Service Note		
Products	Description:	Service note no.
BH550 and BH800	Check value of R29 if fan or main board is replaced	SNo-T221

R29 is situated here

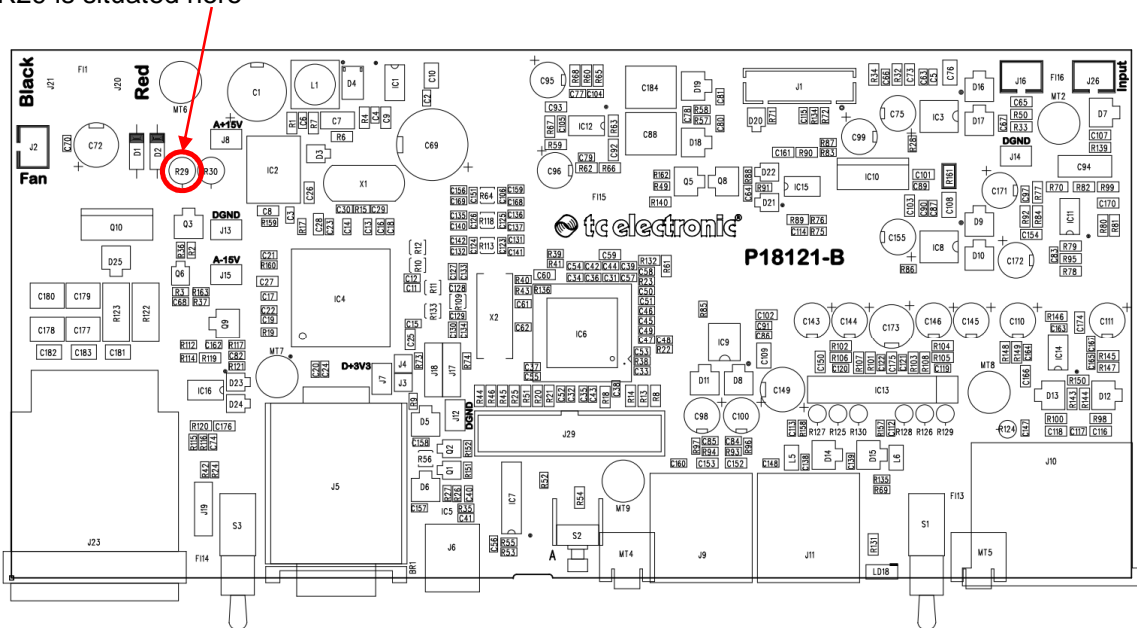
When replacing the fan or the mainboard you have to check the manufacturing part number of the fan and the value of resistor, R29.

Check the marking on the fan.

If it is a Sunon - ME50152V1-000C-A99, R29 must be a 82 ohm/3W. Replace if necessary.
 If it is a Sunon - MF50152VX-1000C-A99, R29 must be a 240 ohm/3W. Replace if necessary.
